Access Compliance Report

Public Rights-of-Way

Intersection ID: 44062	Main Street: WESTMILL_LN	Cross Street: SEDGEMOOR_LN	Location: S
ADA ID: 09895C7A1105	Ramp Type: PerpDiag	Initial Pass/Fail: Pass	Overall Compliance: No
Severity Score: 4			
Codes/Mitigation Info/Possible Solution		Field Measurements/Component Compliance

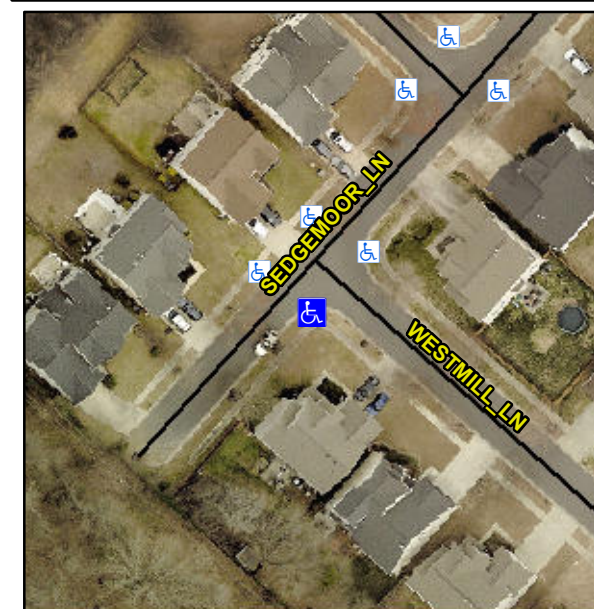
R304.2.1, R304.2.2-Perp, R304.3.2-Para, R305.2

Compliance	Description	Data	Compliance	Description	Data
N/A	Ramp Length (in)	66.0	Yes	Ramp Slope (%)	6.2
Yes	Ramp Width (in)	49.0	Yes	Ramp XSlope (%)	0.7
N/A	Flare Type LT	Sloped	N/A	Flare Type RT	N/A
N/A	Flare Slope LT (%)	1.4	N/A	Flare Slope RT (%)	2.1
N/A	Flare Traversable LT?	No	N/A	Flare Traversable RT?	No
No	Landing Length (in)	47.0	Yes	DWS Provided?	Yes
No	Landing Width (in)	43.0	Yes	DWS Contrast?	Yes
No	Landing Slope (%)	3.1	Yes	DWS Length (in)	24.0
Yes	Landing X Slope (%)	1.9	Yes	DWS Full Width?	Yes
N/A	Landing Curb? (Y/N)	No	No	DWS Offset (in)	4.0
N/A	Shared Landing?	No			
Yes	Gutter Ponding?	No	Yes	Gutter Slope (%)	0.3
Yes	Gutter Lip Ht (in)	0.0	Yes	Gutter X Slope (%)	0.1
N/A	Painted X Walk1?	No	N/A	Painted X Walk2?	No
	X Walk 1 Direction	To NE		X Walk 2 Direction	To NW
N/A	X Walk 1 Width (in)	N/A	N/A	X Walk 2 Width (in)	N/A
	X Walk 1 Slope (%)	2.4		X Walk 2 Slope (%)	3.3
	X Walk 1 X Slope (%)	2.6		X Walk 2 X Slope (%)	1.1

N/A	Ramp inside XWalk1?	N/A	N/A	Ramp inside XWalk2?	N/A
	Road Slope (%)	1.6	N/A	Clear Space?	Yes
	Road X Slope (%)	3.2	N/A	Clear Space to XWalk (in)	N/A
Yes	Any Obstructions?	No	Yes	Storm Grate/Utility Hazard?	No
	Obstruction Type			Storm Grate/Utility Type	
		N/A			N/A
		Yes		Surface Condition? (G/P)	Good

Remove & Replace Curb Ramp With Two New Directional Ramps or Equivalent.
